HISTORIC AND DESIGN REVIEW COMMISSION

HDRC CASE NO: 2021-164
ADDRESS: 315 E PECAN ST
LEGAL DESCRIPTION: NCB 413 BLK 11 LOT 3-4- 5, 6 & E 27.8 FT OF 2
ZONING: D,HE
CITY COUNCIL DIST.: 1
LANDMARK: St Mark's Episcopal Church
APPLICANT: Tobin Hays/Ford, Powell and Carson Architects and Planners
OWNER: Eric Nelson/ST MARKS EPISCOPAL CHURCH
TYPE OF WORK: Window replacement
APPLICATION RECEIVED: February 04, 2021
60-DAY REVIEW: Not applicable due to City Council Emergency Orders
CASE MANAGER: Stephanie Phillips

REQUEST:

The applicant is requesting a Certificate of Appropriateness to replace all existing six over six wood windows on the 1920s Parish Hall and 2012 addition with new aluminum clad wood windows to match the historic windows in profile, inset, configuration, and detailing.

NORTH ELEVATION

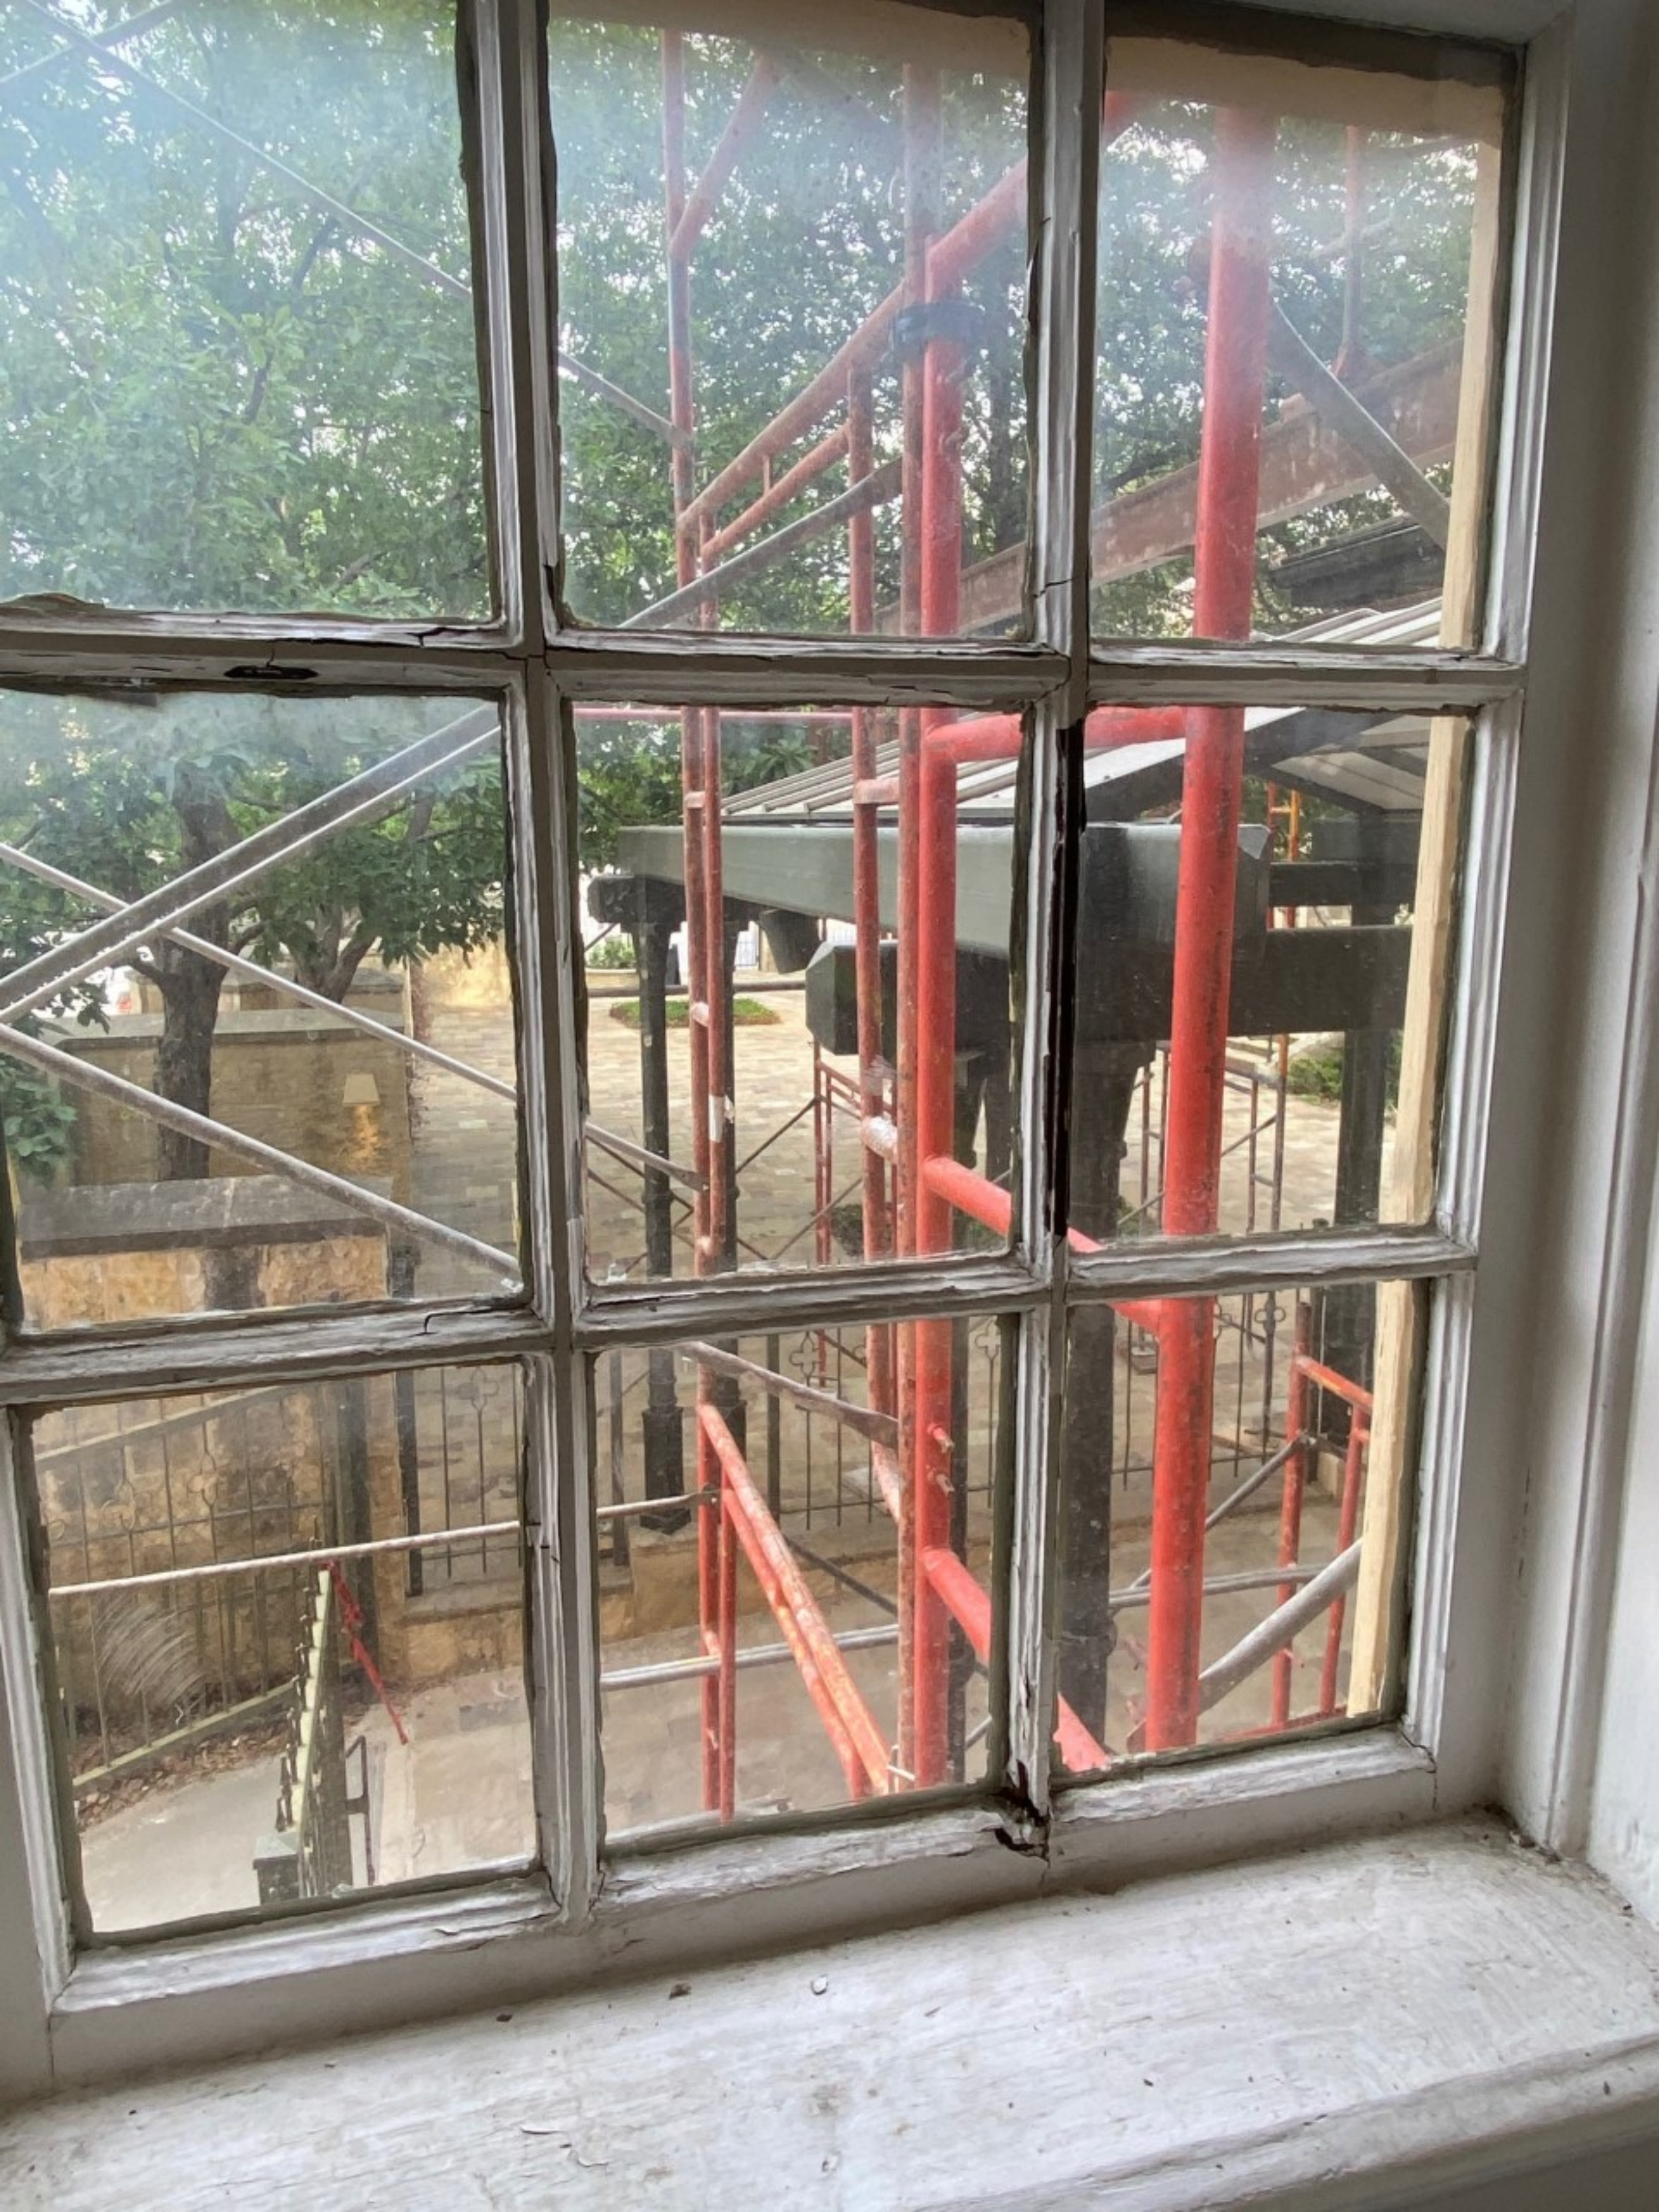
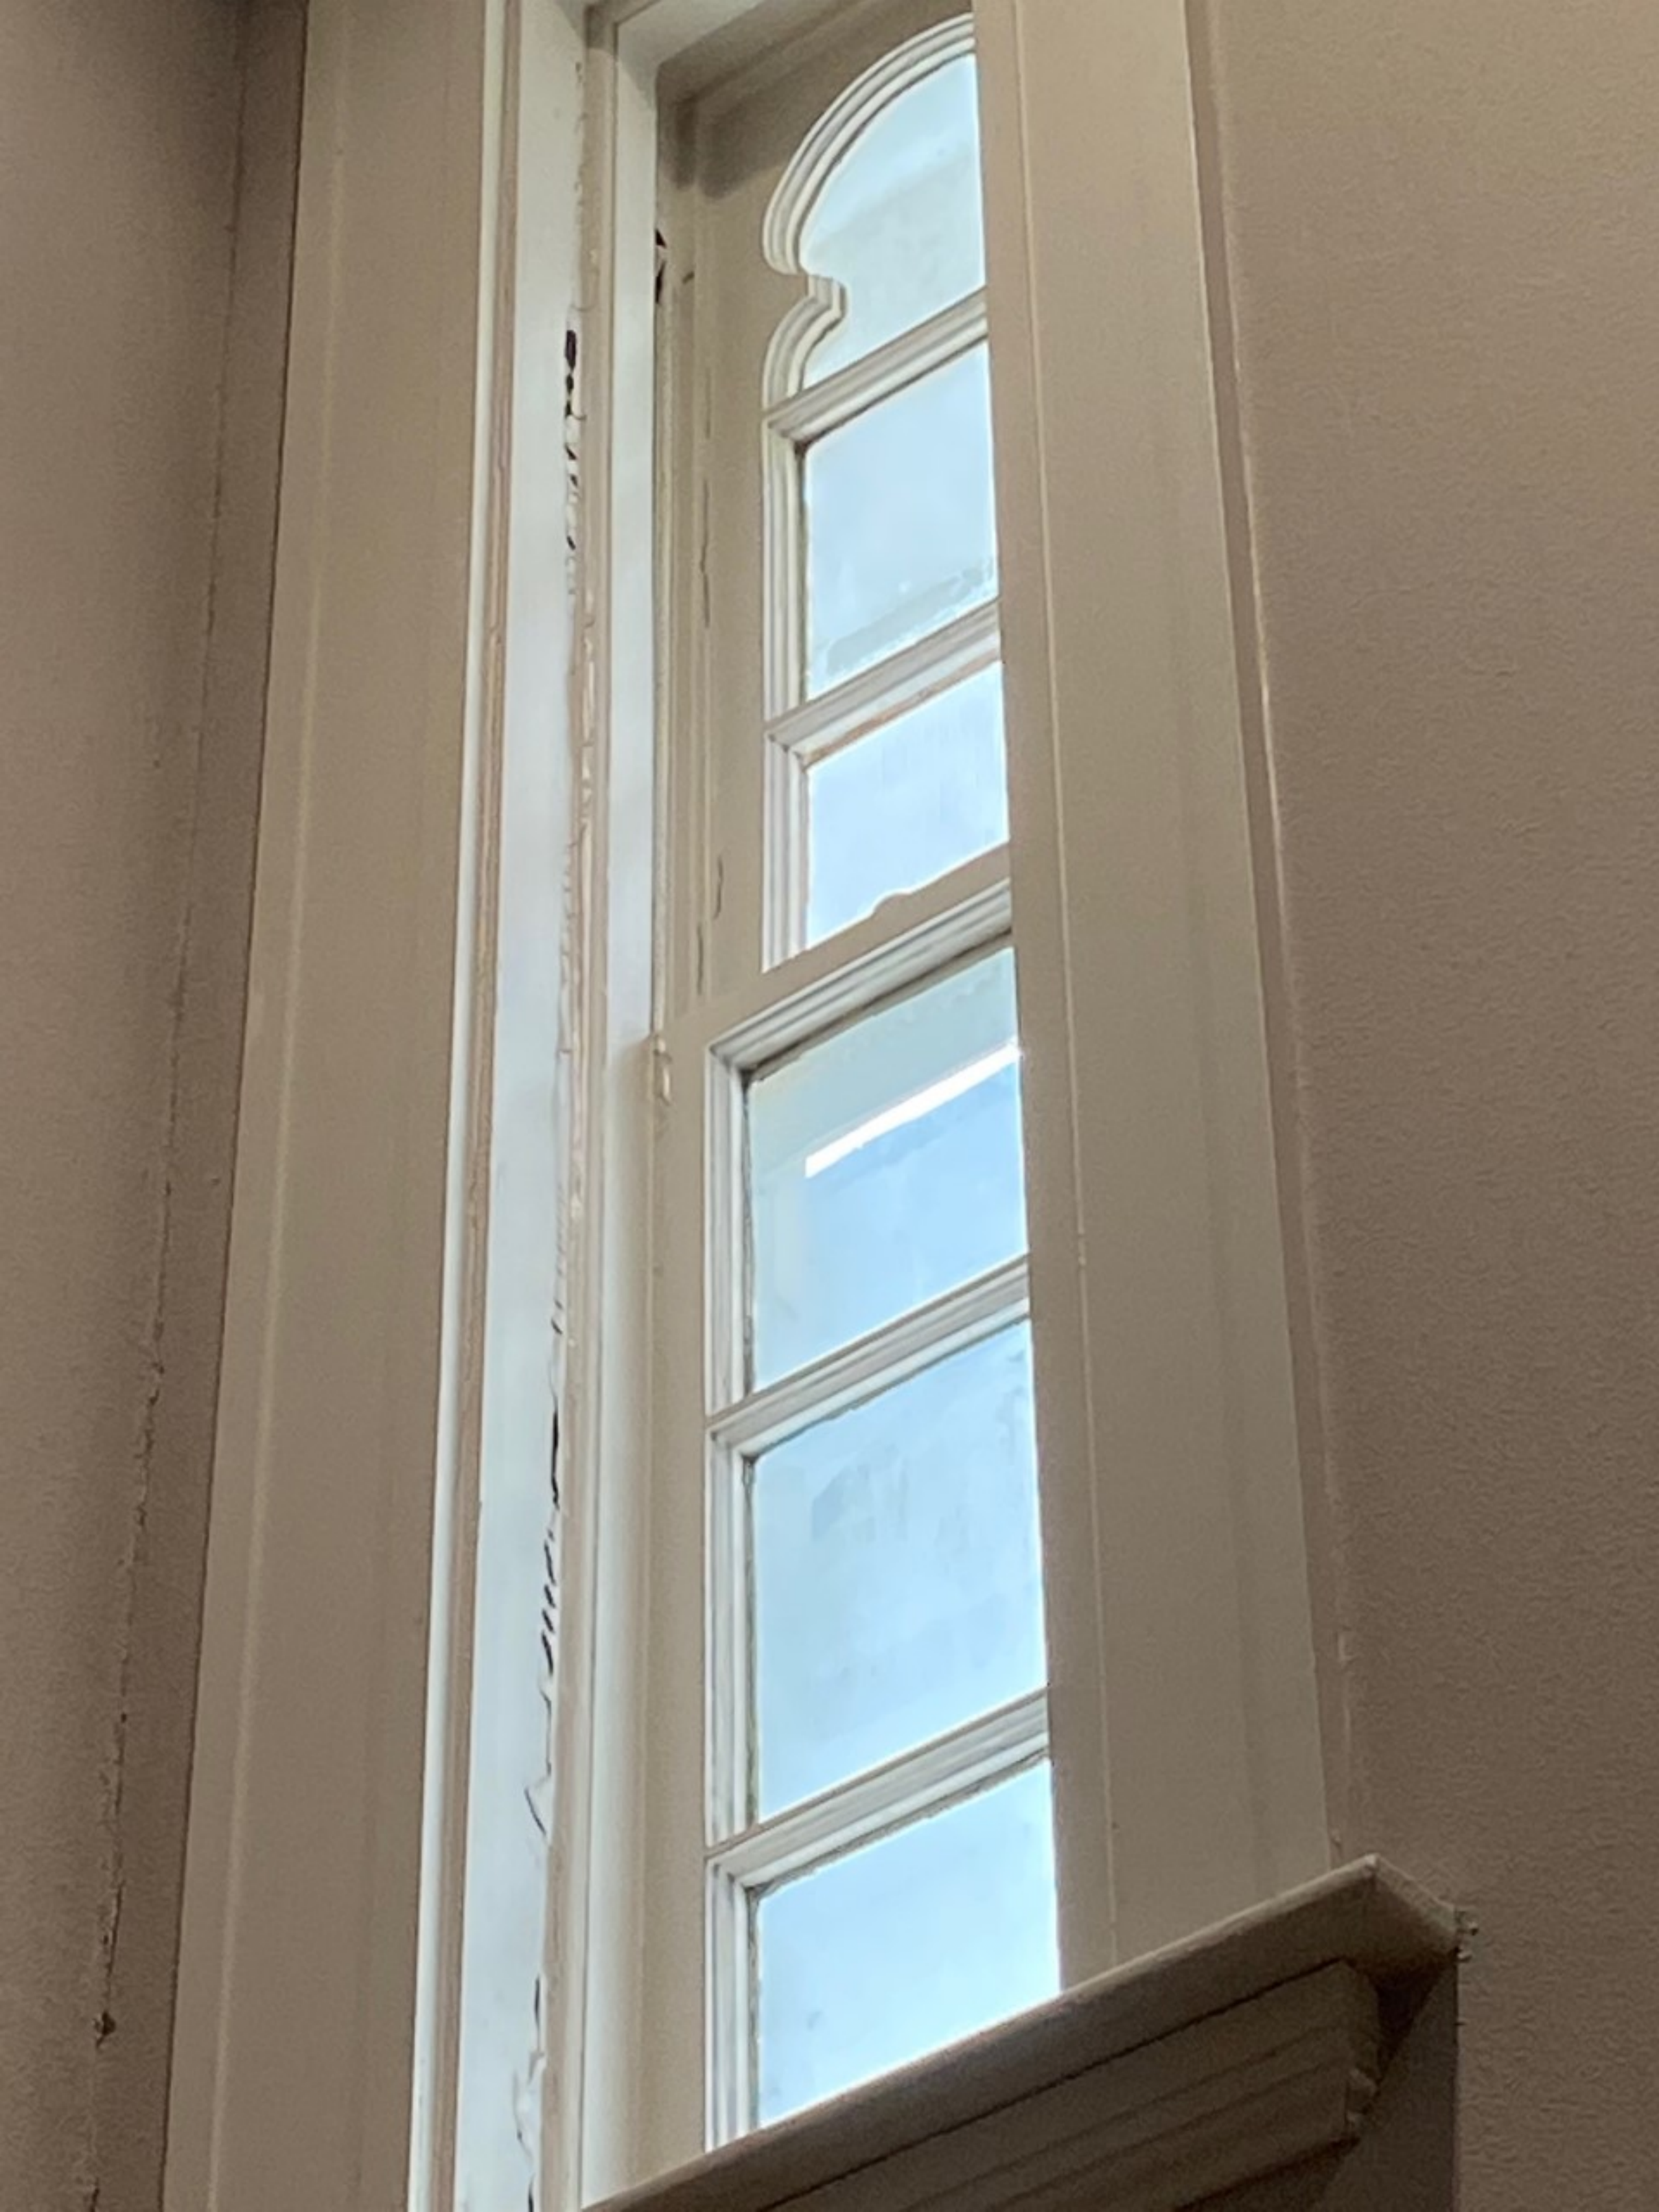
■ RESTORE WINDOW
■ REPLACE WINDOW

- i. That the applicant restores the original wood windows on the first floor as noted in finding d. If, when undergoing repair, the applicant finds evidence of deterioration beyond repair of an assembly (more than 50 percent of original wood components require replacement) on the first floor, the applicant may relocate repairable windows from the upper floors or other portions of the building where matching windows are available. Updated repair and/or relocation plans are required to be submitted to staff over the course of construction for review and approval, in addition to extensive documentation illustrating deterioration beyond repair.

- ii. That the new replacement windows for the upper stories match the existing in terms of size, configuration, true divided lites, and inset. Openings shall not be modified to accommodate stock sizes. Final drawings and product specifications are required to be submitted to staff for review and approval prior to the issuance of a Certificate of Appropriateness, and a mock up must be installed on site for field verification.
